JORDAN

JORDAN REVISION LIST - STRUCTURAL:

JORDAN **REVISION LIST - ARCHITECTURAL:**

REV.: MAY 01, 2020

A-6.1

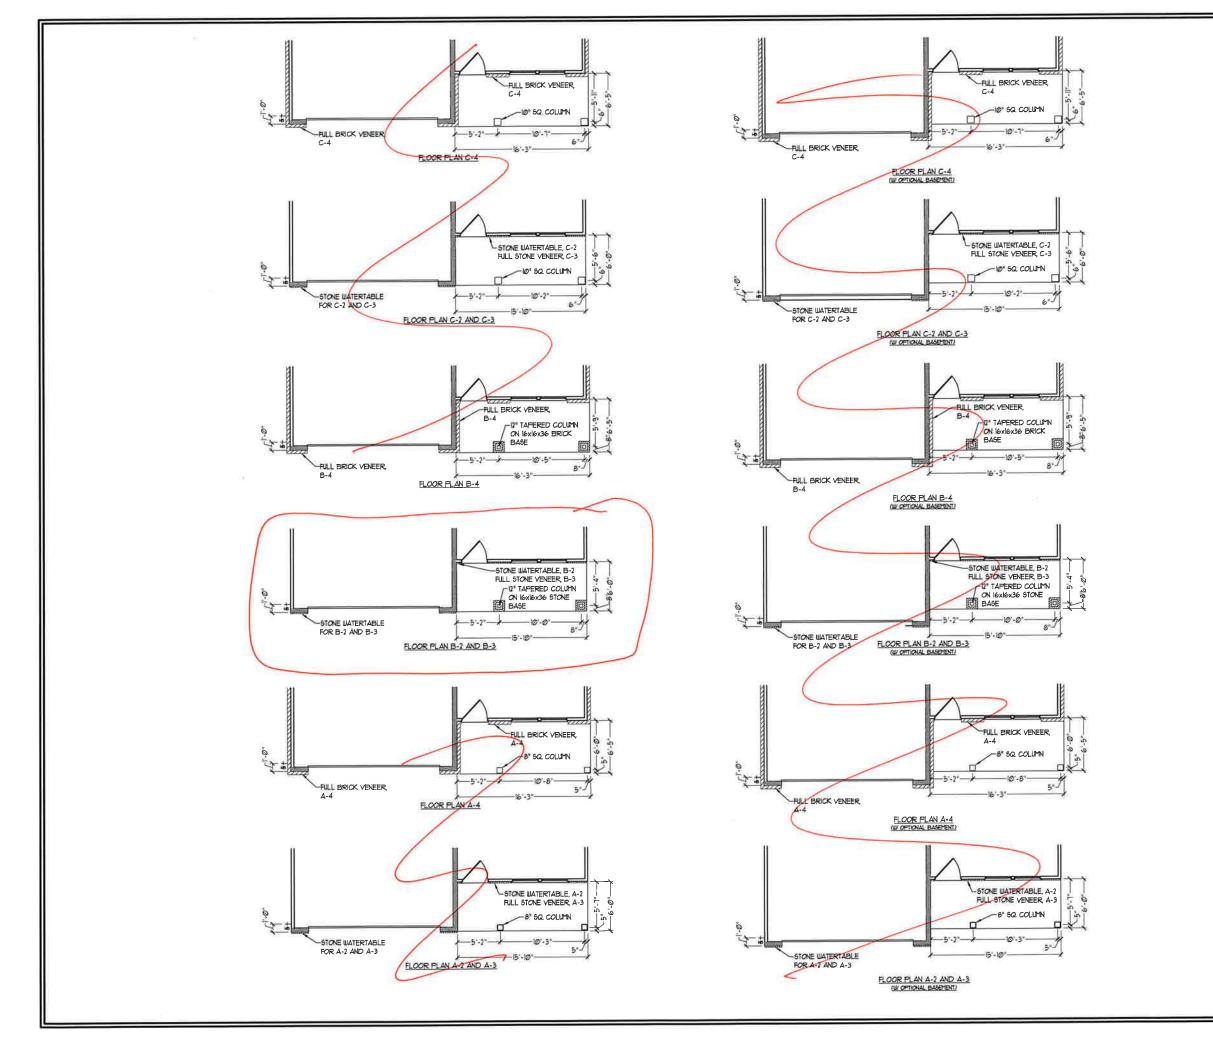
CHANGED SWING OF SERVICE DOOR IN GARAGE TO OUT SWING (SEE SHEET A6.1) (7-8-20)
